The Town of Hilton Head Island
Design Review Board Regular Meeting
Tuesday, July 16, 2019 – 1:15 p.m.
Benjamin M. Racusin Council Chambers
AGENDA

Bauer and Metro
 Landscape Plan for New Sign & Back of Building
 38 A New Orleans Road Hilton Head Island SC February 2019

SITE PLAN
NORTHRIDGE PLAZA IMPROVEMENTS
 TOWN OF HILTON HEAD ISLAND, SOUTH CAROLINA
 PREPARED FOR:
GATOR NORTHRIDGE PARTNERS, LLLP

CENTURY 21
Advantage Properties

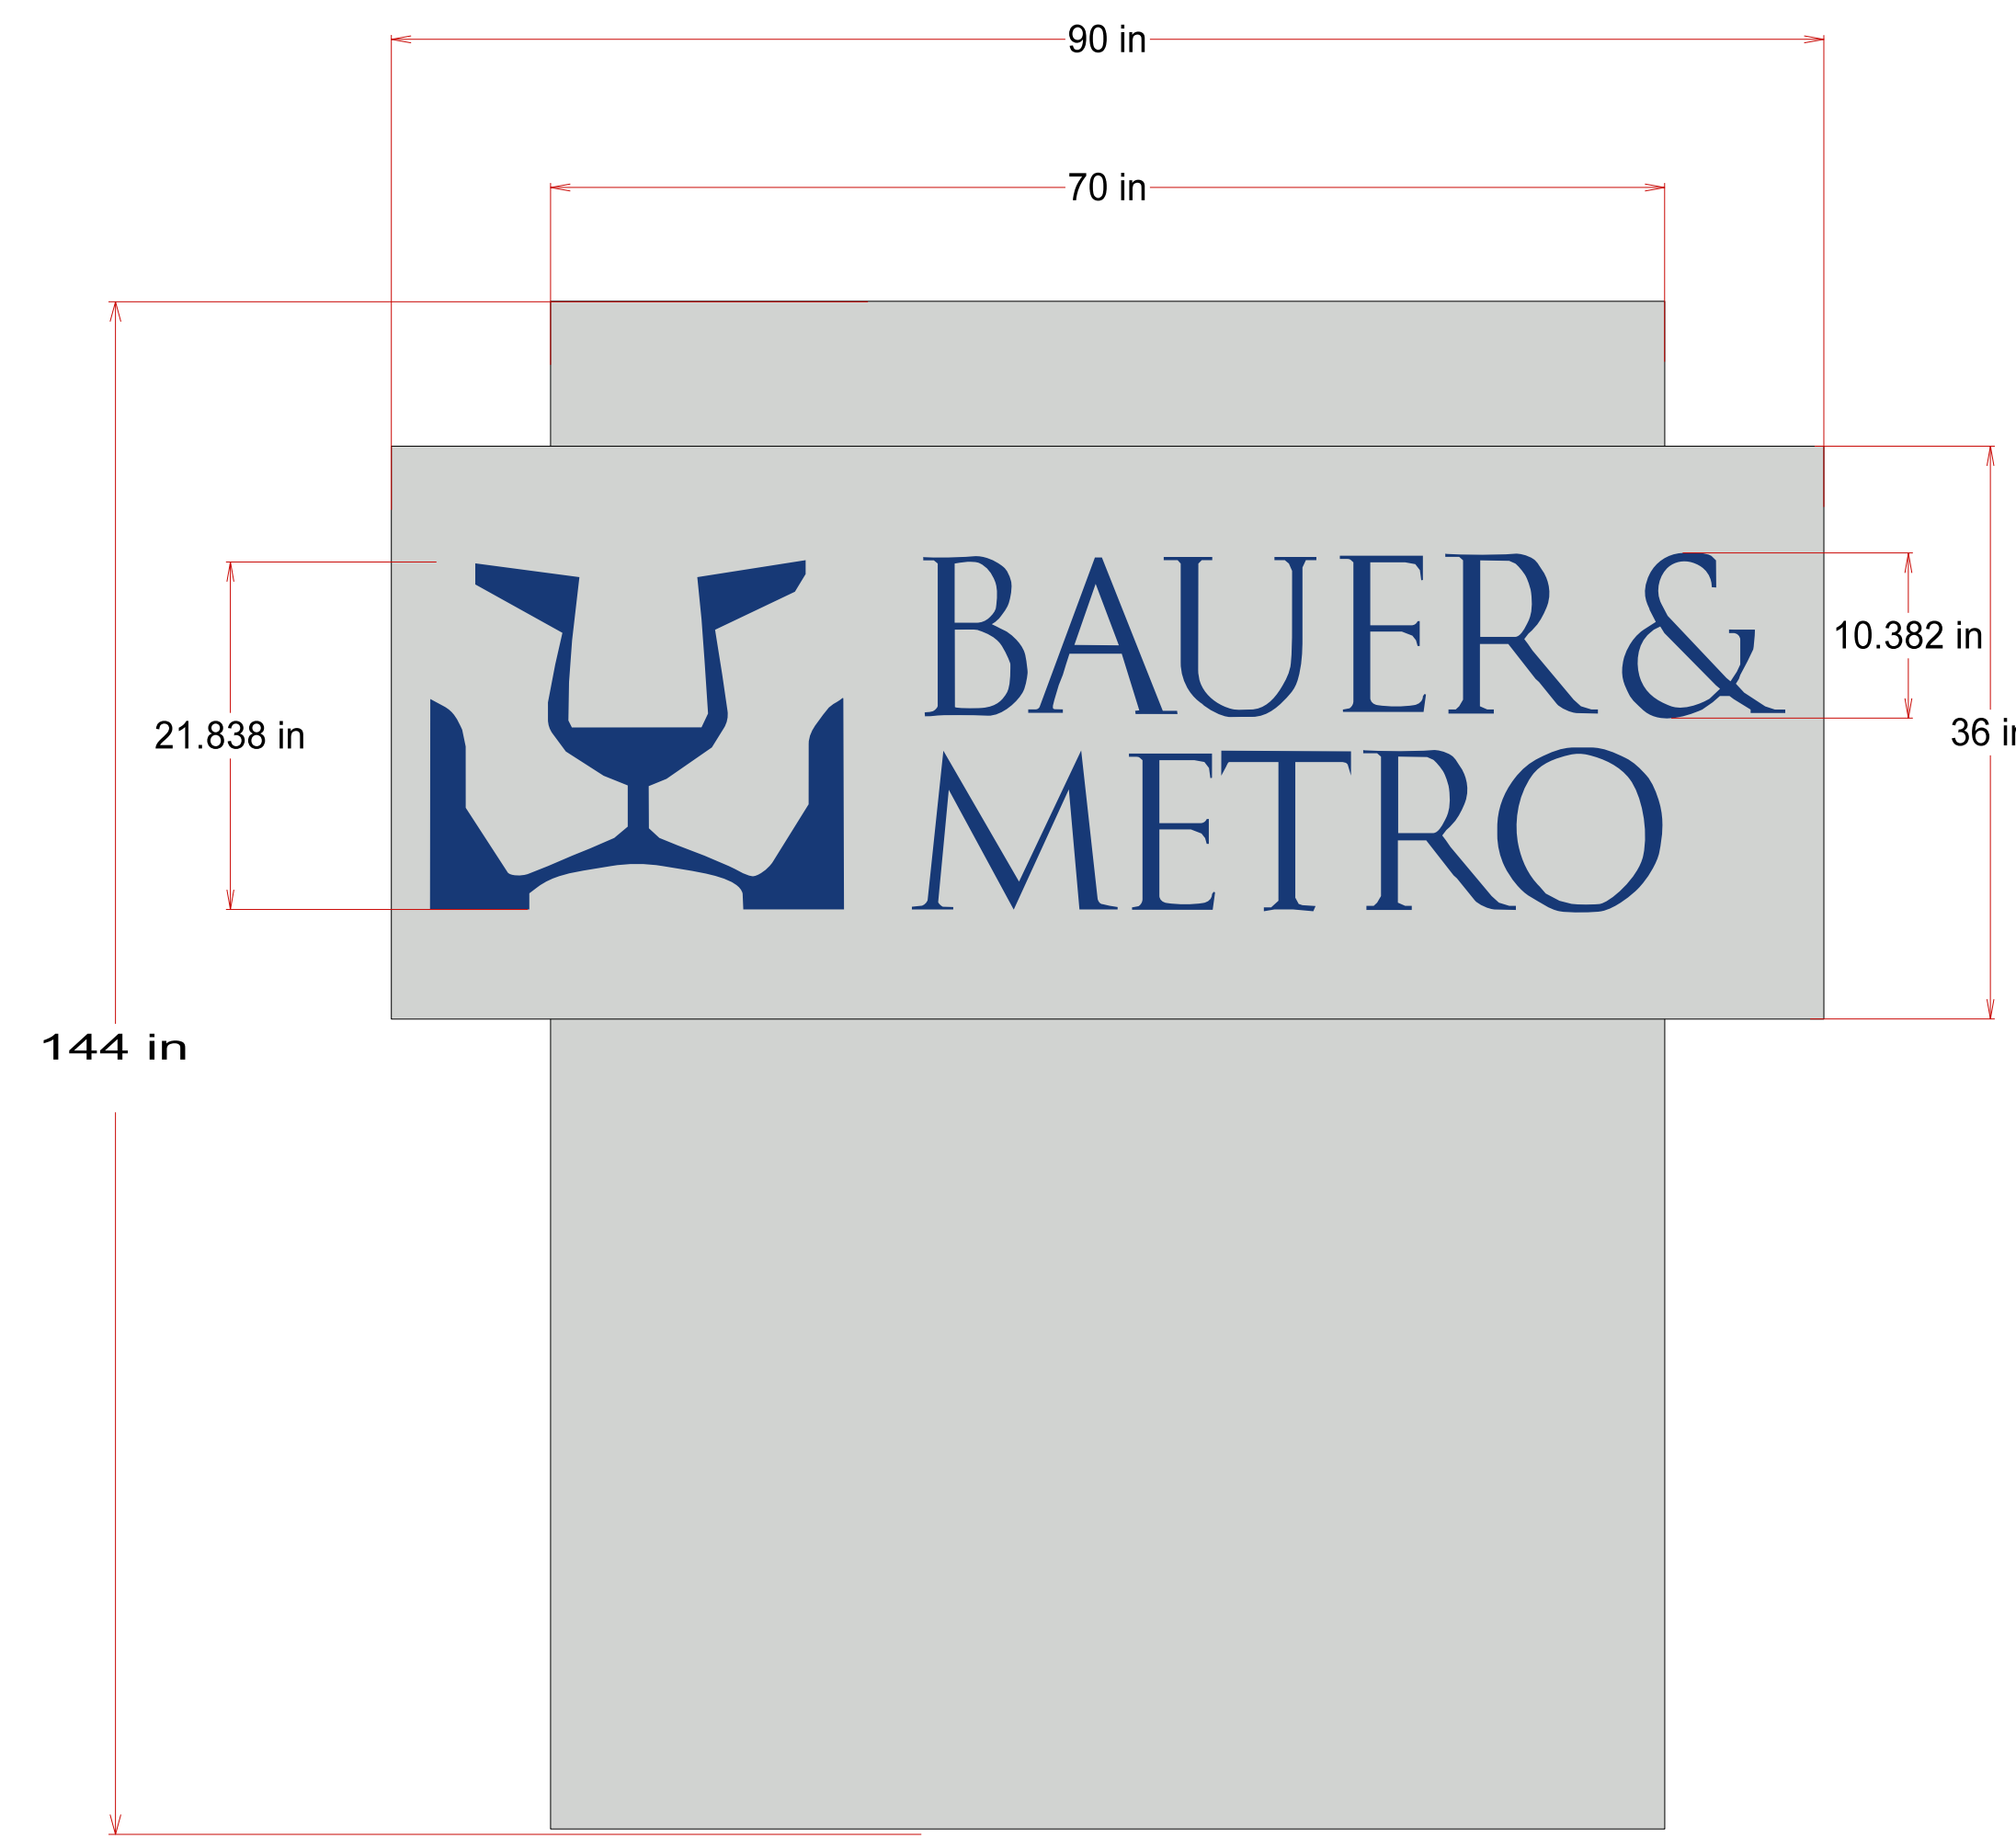
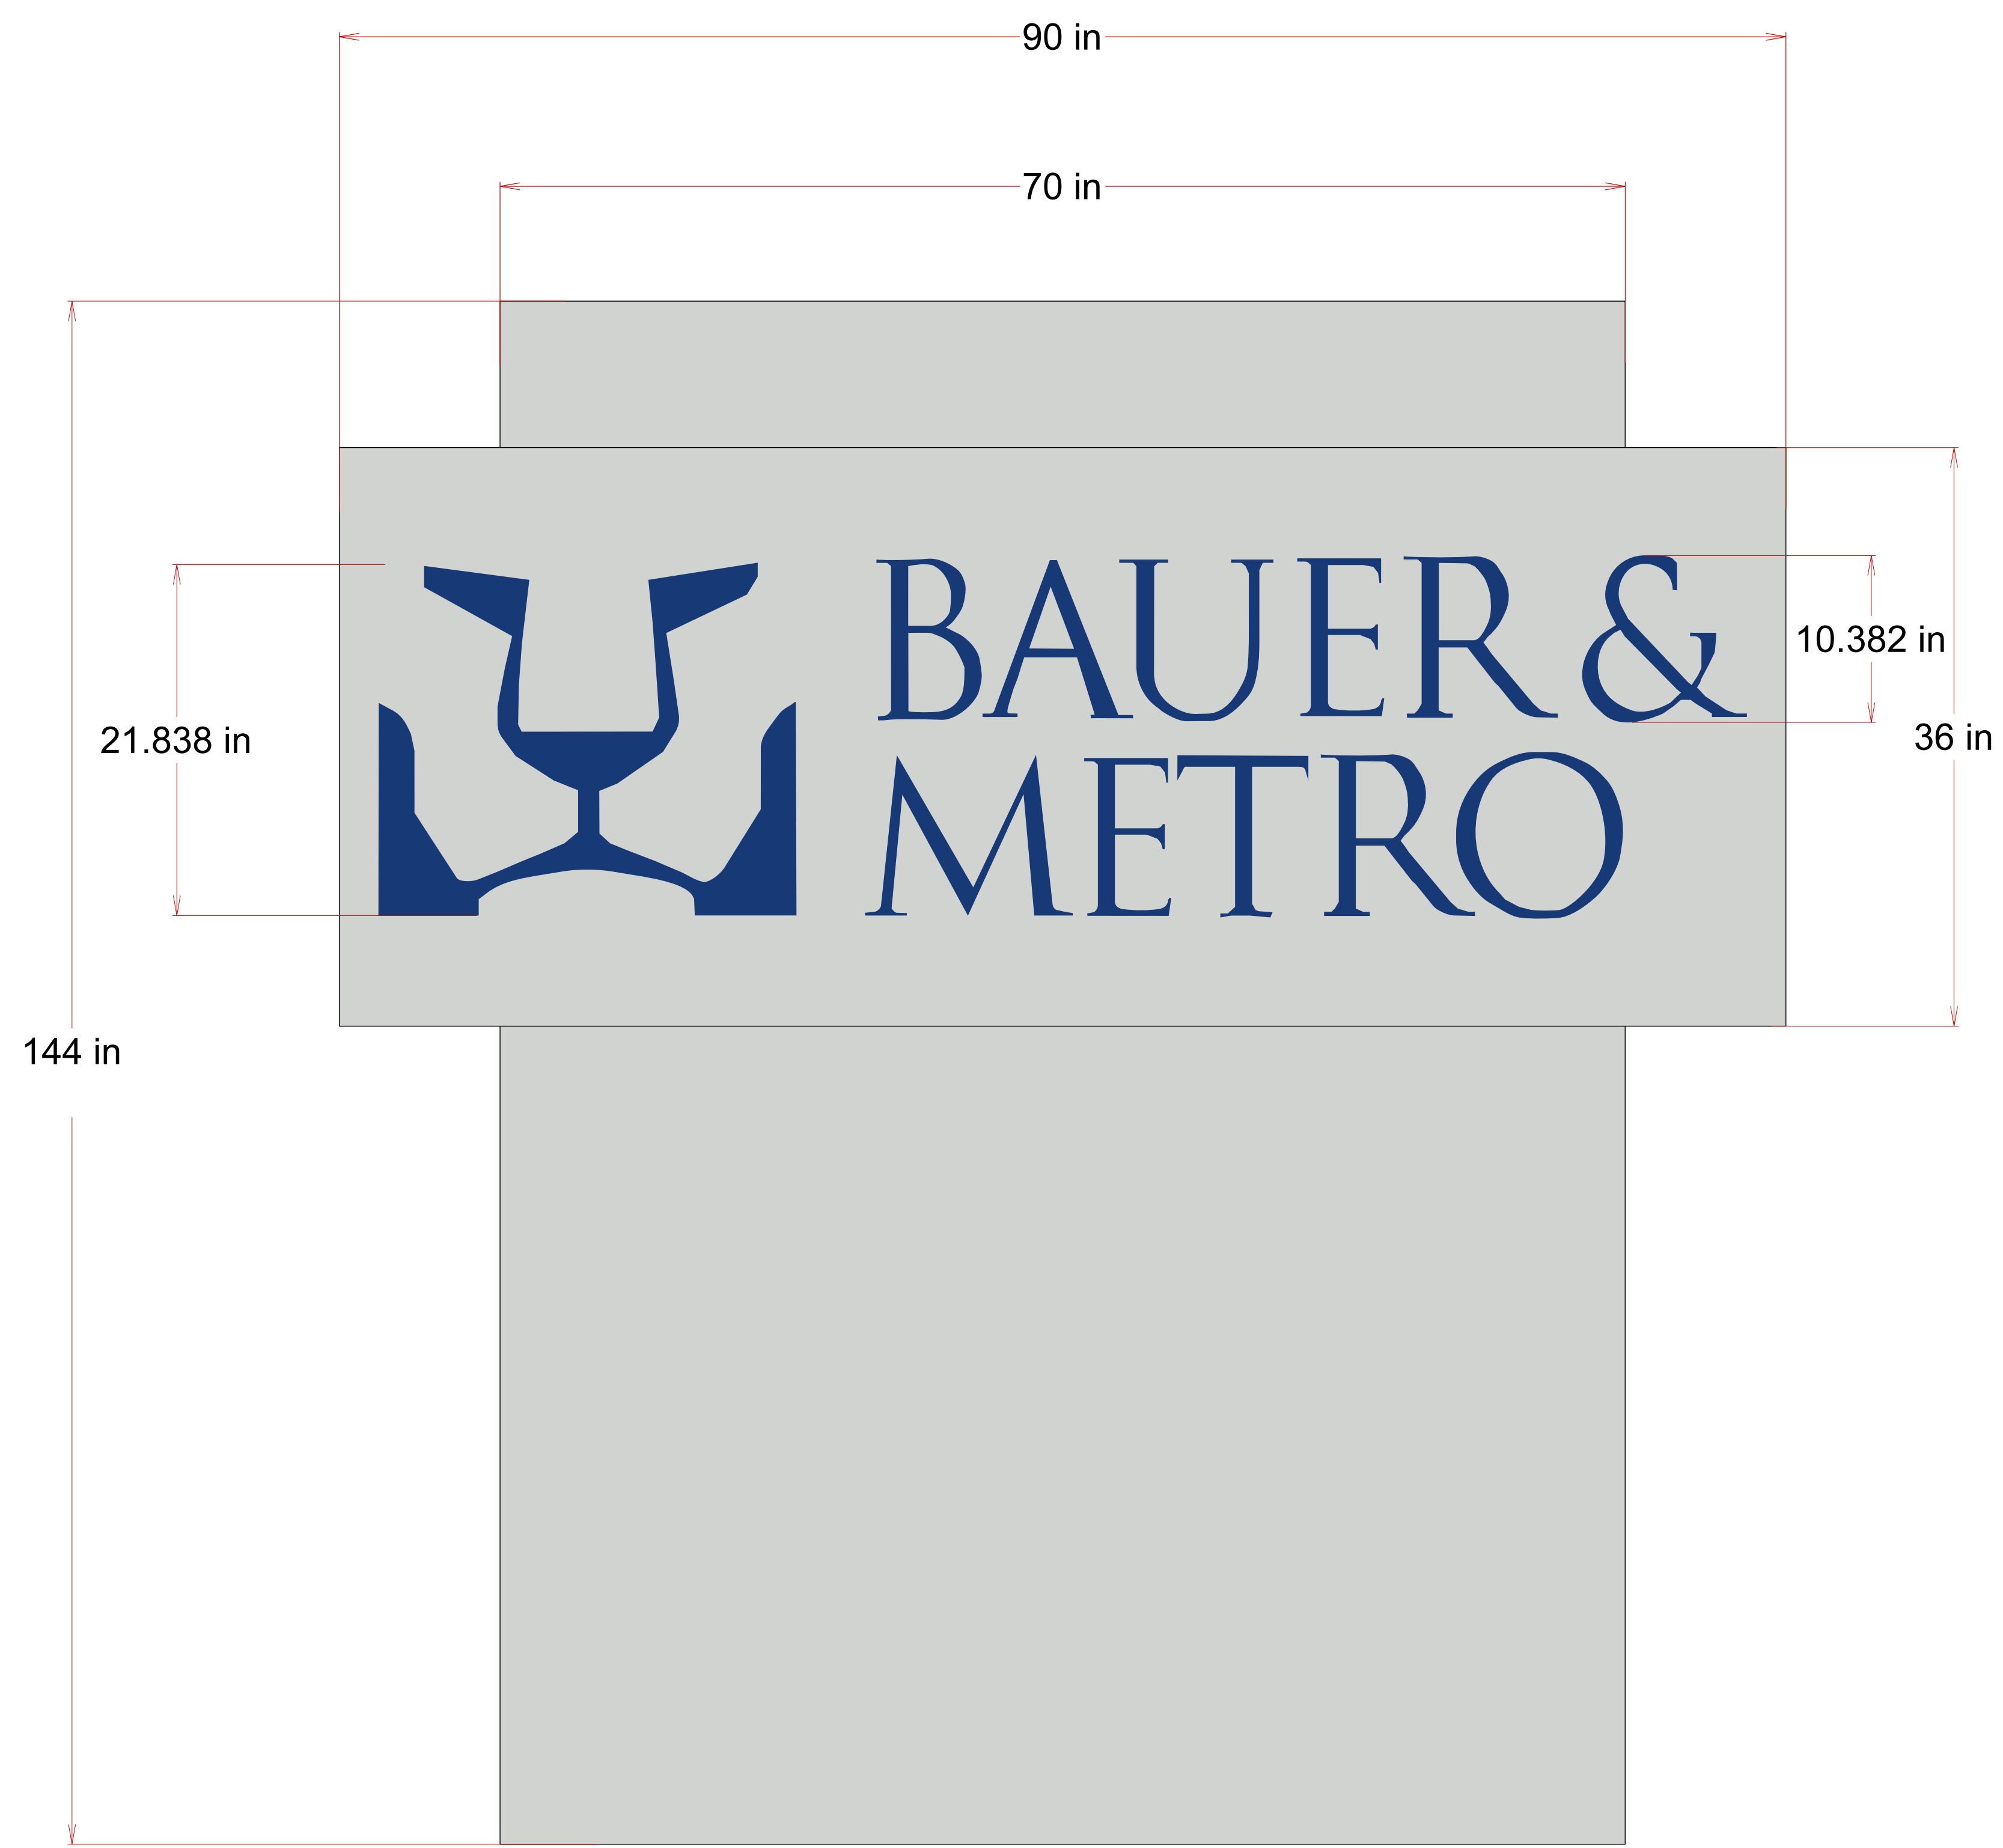
1. It is unclear if the applicant is requesting removal of all the understory (azaleas) from the site. Please clarify on the landscape plan by indicating existing understory to remain.
2. Relocating the sign to a cleared area will eliminate the need to remove additional trees, i.e. 20" pine.

REQUIRED INFORMATION & DESIGN STANDARDS	Yes	No	N/A	Comments & Questions
Structure or post materials are listed, e.g. “Concrete block with stucco”, “4 inch x 4 inch wood posts”.		X		Provide a detail or note the type of construction the structure is, i.e. concrete block or wood frame. Should match the other existing signs.

REQUIRED INFORMATION & DESIGN STANDARDS	Yes	No	N/A	Comments & Questions
The sign does not exceed the size limit in LMO Section 16-5-114.F.	X			The sign height is limited to 8'

REQUIRED INFORMATION & DESIGN STANDARDS	Yes	No	N/A	Comments & Questions
The street address of the site is shown in 4 inch tall numbers on both sides of the sign. Note: The street name may be also required if the site accesses more than one street.		X		
If the street address is not located on the sign face, it is well-integrated into the sign design so that it does not look like an afterthought.		X		
Sign panels: The background texture matches the texture of other sign panels on site.		X		The sign structure should match the other

REQUIRED INFORMATION & DESIGN STANDARDS	Yes	No	N/A	Comments & Questions
Colors reflect/complement the colors on the building walls, trim, etc.		X		
Colors match the other signs on site for that business or development.		X		The wood elements on the other signs picks up the color of the wood siding on the building. This proposed sign should as well. Specify on the plans color to match building.
Background colors are earth tones: green, brown, beige, and grey.		X		The proposed stucco color should match the building stucco as closely as possible. Navajo White is not appropriate for the sign structure, it is too white. Specify on the plans color to match building.

REQUIRED INFORMATION & DESIGN STANDARDS	Yes	No	N/A	Comments & Questions
For new signs or signs without existing lighting, rendering states: “New lighting will be installed” or “The sign will not be illuminated.”		X		Please add note to the sign plans.
